4/15/02 - 1:30pm - Pump TEST

PERMIT
SEWAGE DISPOSAL SYSTEM
HOWARD COUNTY HEALTH DEPARTMENT
BUREAU OF ENVIRONMENTAL HEALTH
410-313-2640

P 514242

ADDRESS 17550 Old Frederick Road, Mt. Airy, MD 21771 PHONE 410-549-2575

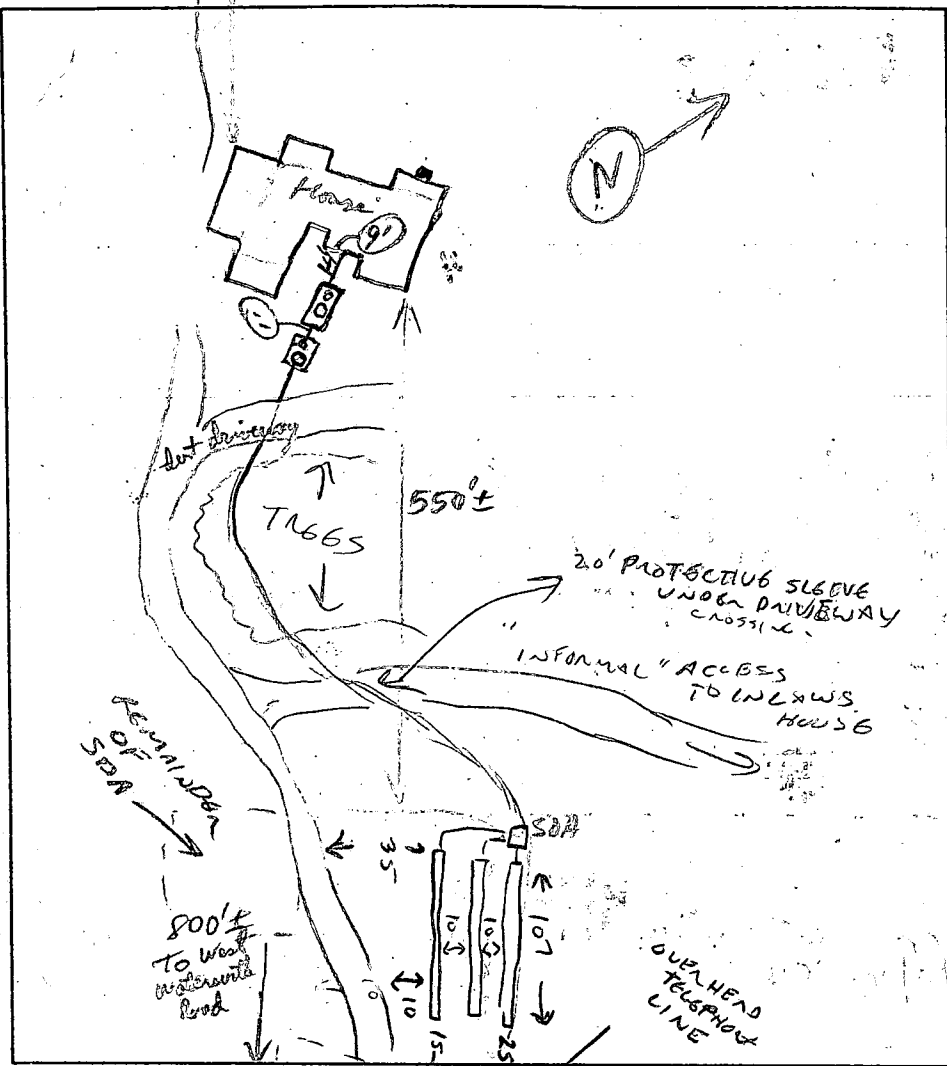
INSPECTION COMMENTS: CORNERS OF SEPTIC AREA STAKES OK FOR 3 TRENCHES @ 107'.
Moderately Stacey Tank floor, PC set back from 1000 gal section is P.C., 500 gal is second section tank
Baffle OK @ inlet of PC & outlet of Septic Tank, No inlet ST. Baffle Mark Horse Connection. RPP 9/24/00
DISTRIBUTION BOX & 3 TRENCHES COMPLETE; OK TO COVER 10/20/00 CW
HOUSE CONNECTION, EFFLUENT LINE COMPLETE & OK TO COVER 10/26/00 CW

2/11/02 - PUMP & ALARM NOT WORKING - TOLD CONTRACTOR TO CALL WILL HOPKINS
ELECTRICIAN & PUMP INSTALLER (SEPTIC) TO FIGURE OUT PROBLEM (SRD)

INSPECTOR Steve Carter DATE SYSTEM APPROVED 4/15/02
4/15/02 Pump & Alarm tests OK. Well has rope thru vent in cap.
Needs to be fixed (E)

PROPOSAL
 15 FAN
 FIRST FLOOR SERVICE
 ONLY
 NO OBJECTION IF
 TANKS ARE SET
 LOWER ON LOT,
 NOT DEEPER
 IN GROUND
 EX. SEPTIC
 PROVIDE
 BASEMENT
 SERVICE

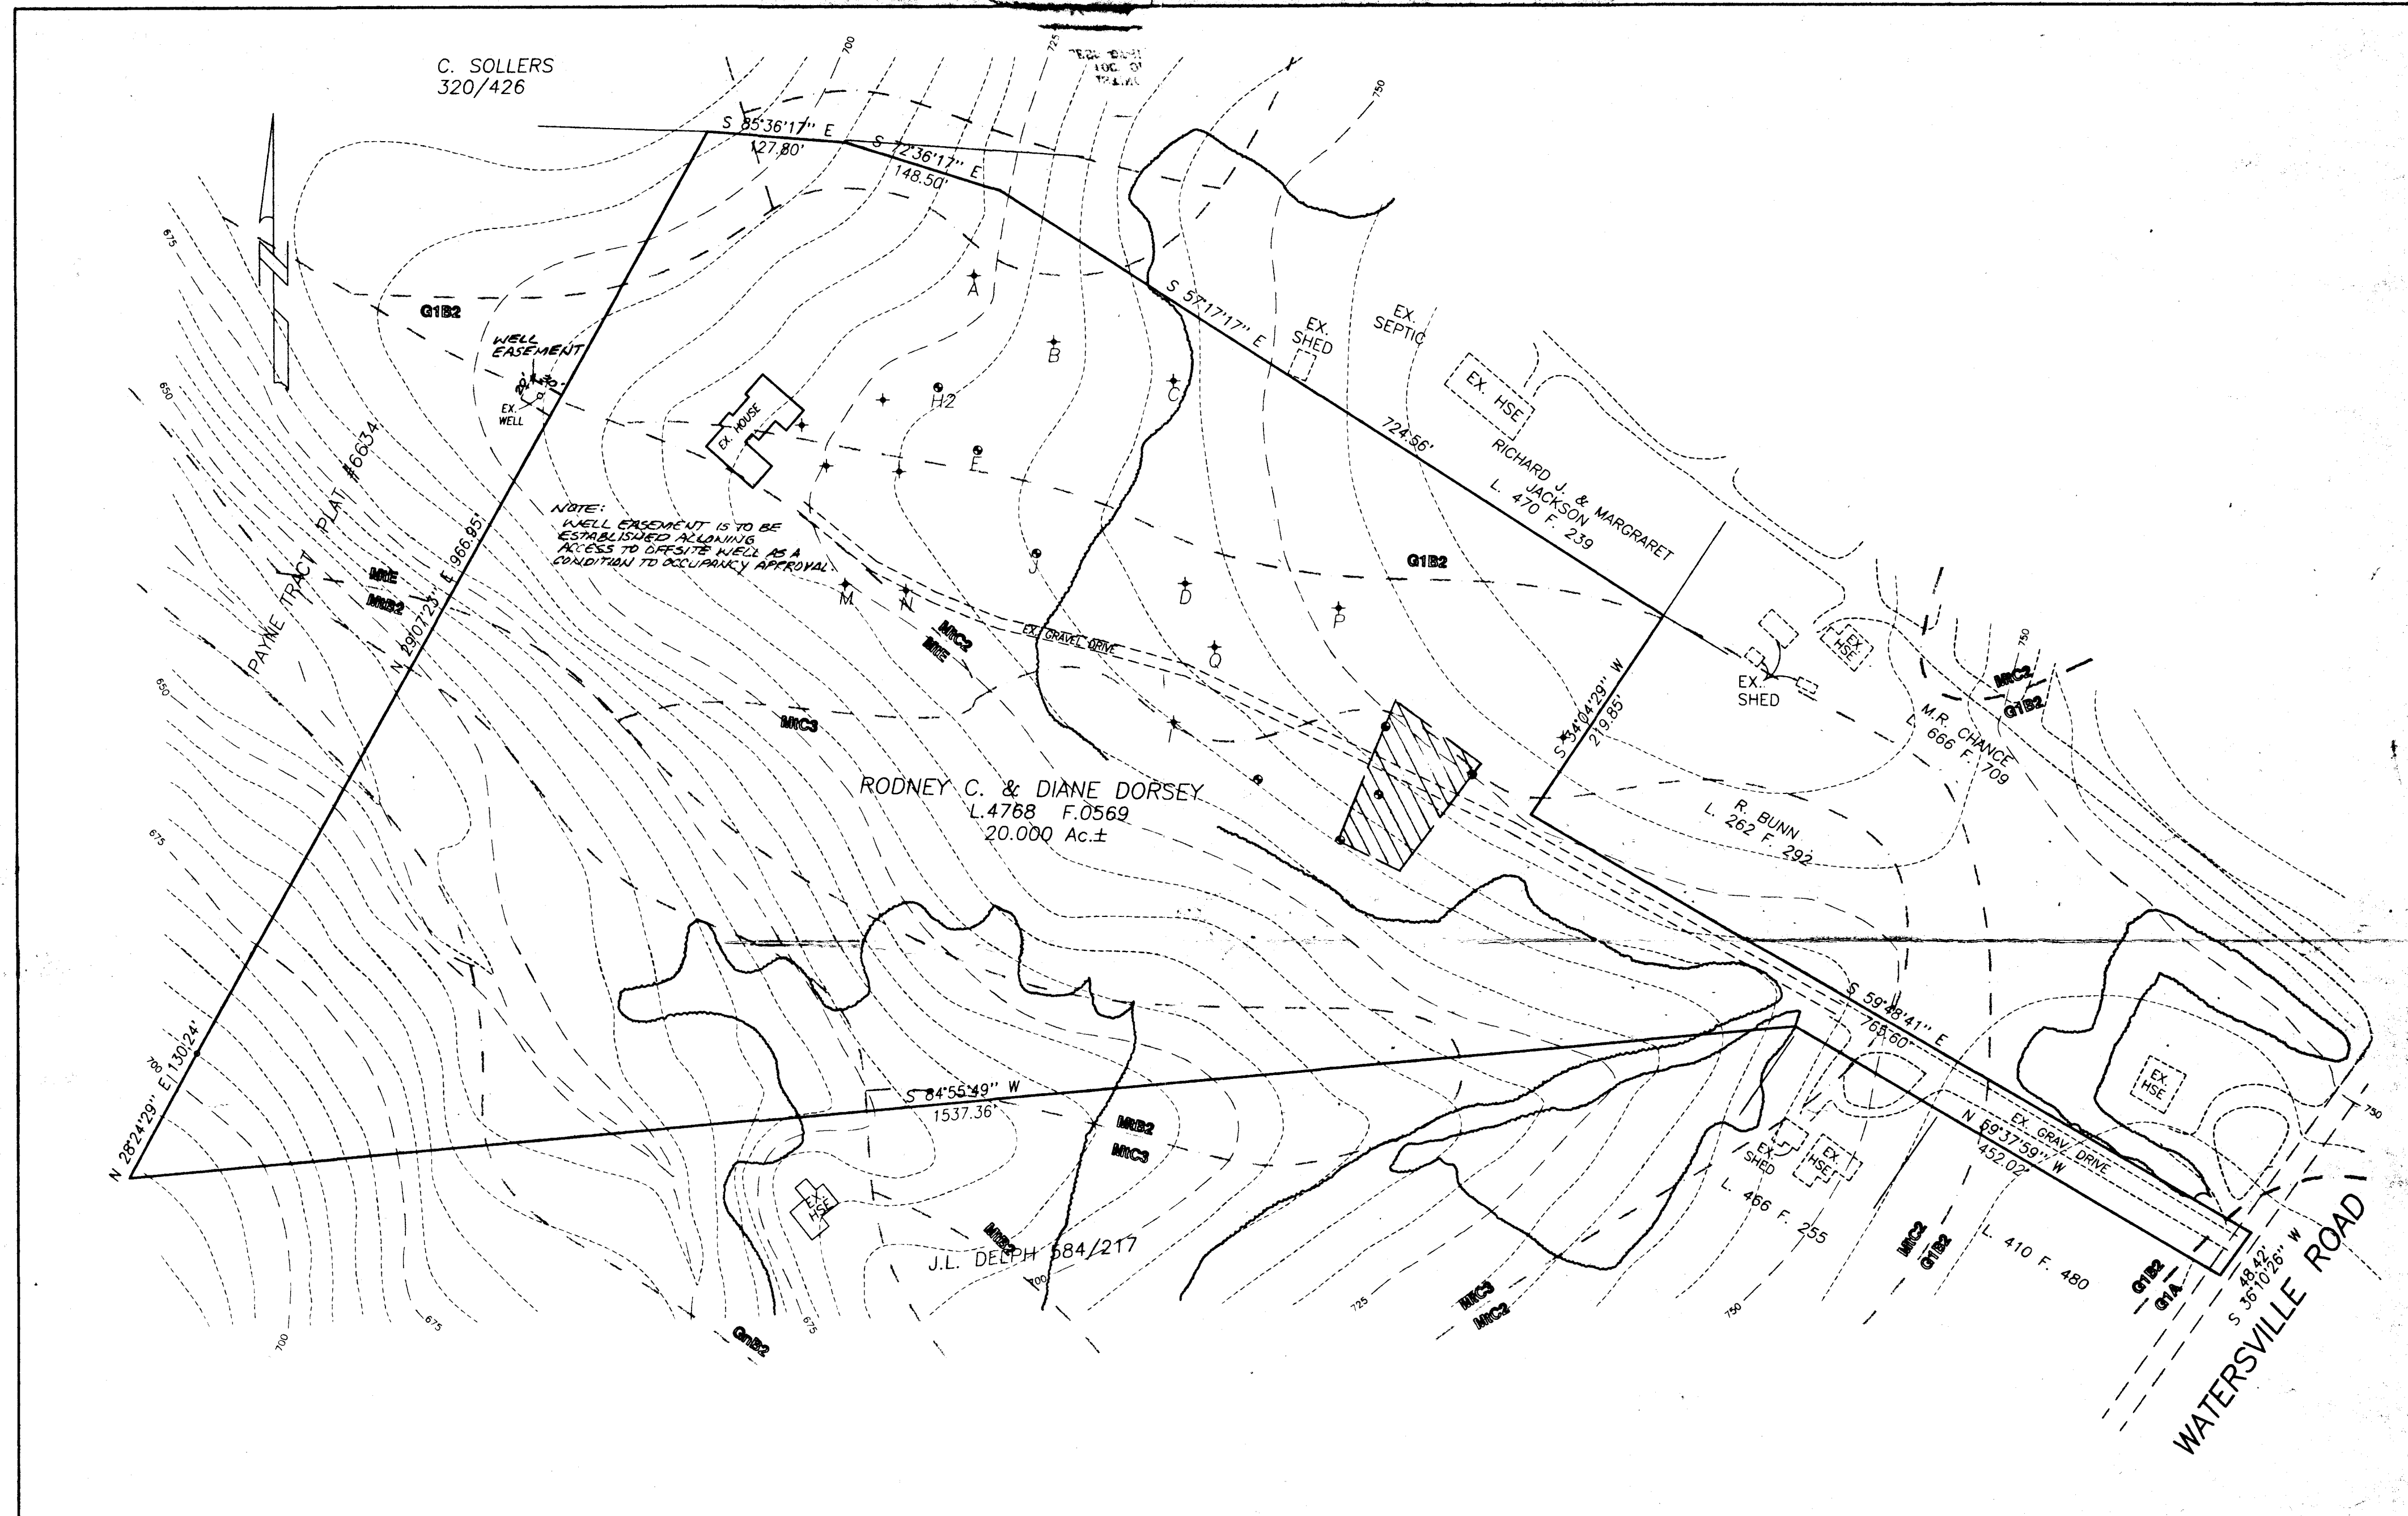
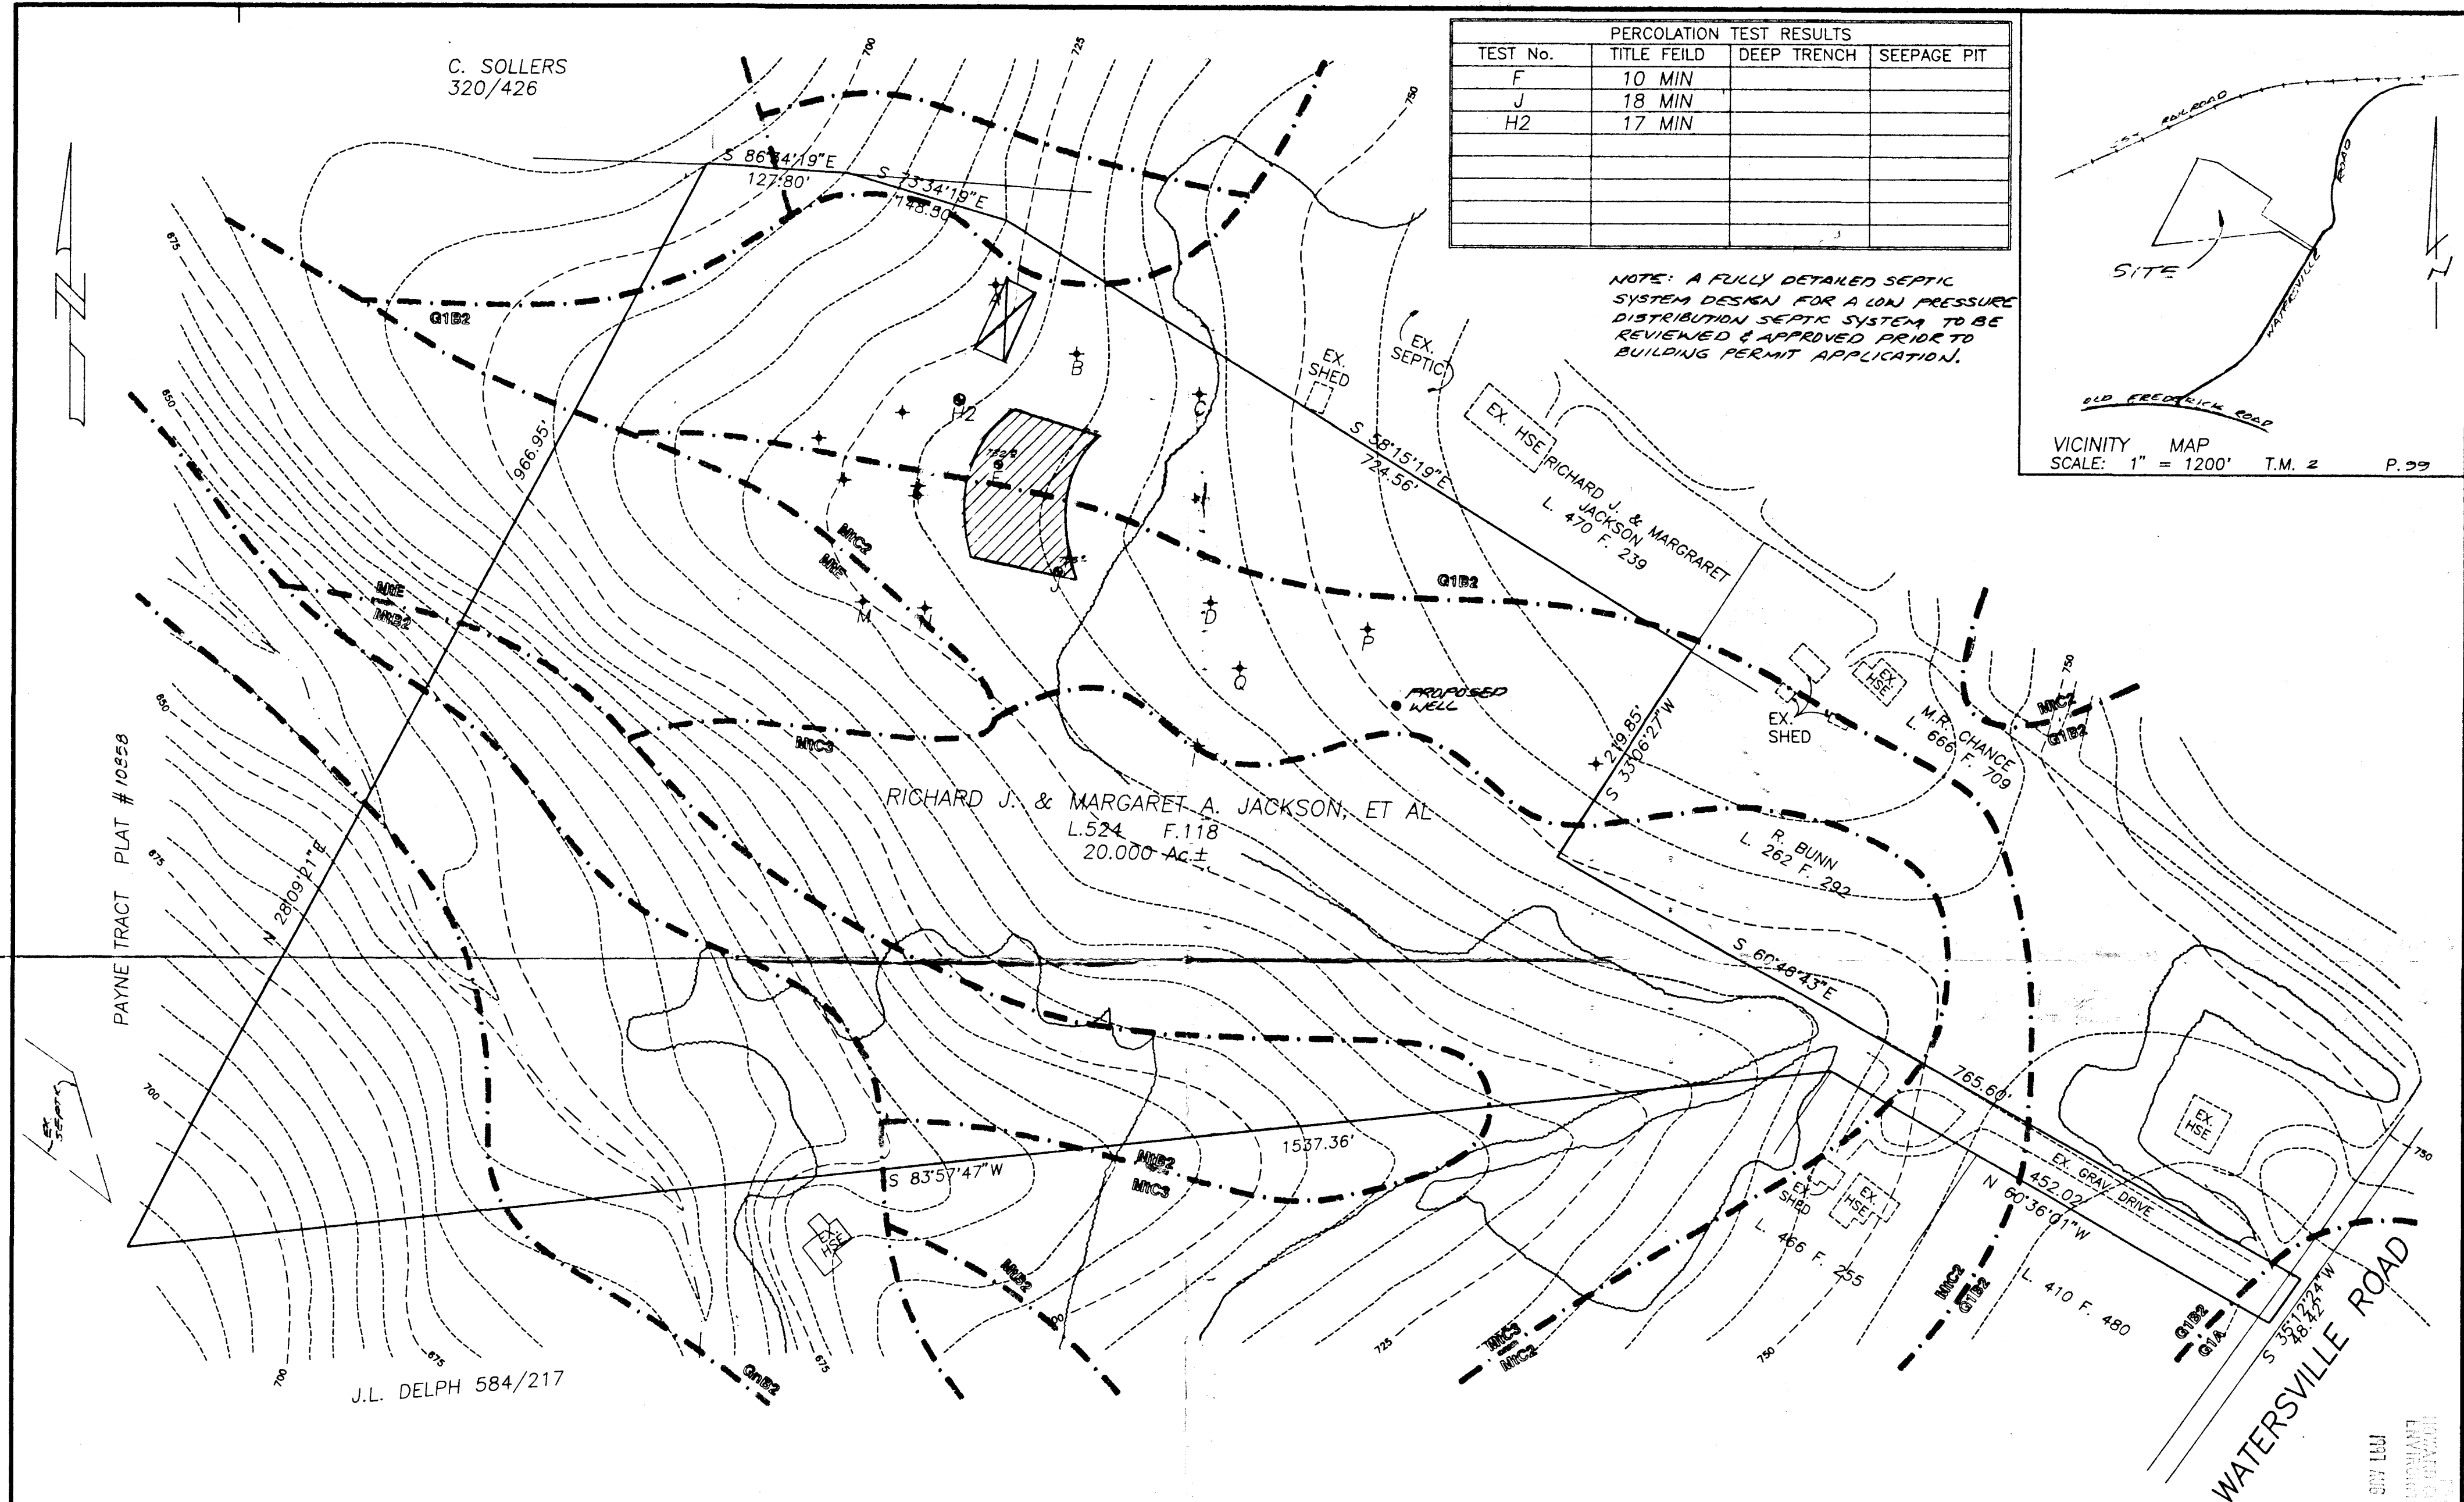
<table><tr> <th>DATE</th> <th>REVISIONS</th> </tr><tr> <td>8/17/97</td> <td>PER COMMENTS</td> </tr><tr> <td>7/24/00</td> <td>REVISED PERC LOCATIONS</td> </tr><tr> <td>8/24/00</td> <td>SEPTIC & WELL EASMT.</td> </tr></table>

NOTE: A FULLY DETAILED SEPTIC SYSTEM DESIGN FOR A LOW PRESSURE DISTRIBUTION SEPTIC SYSTEM TO BE REVIEWED & APPROVED PRIOR TO BUILDING PERMIT APPLICATION.
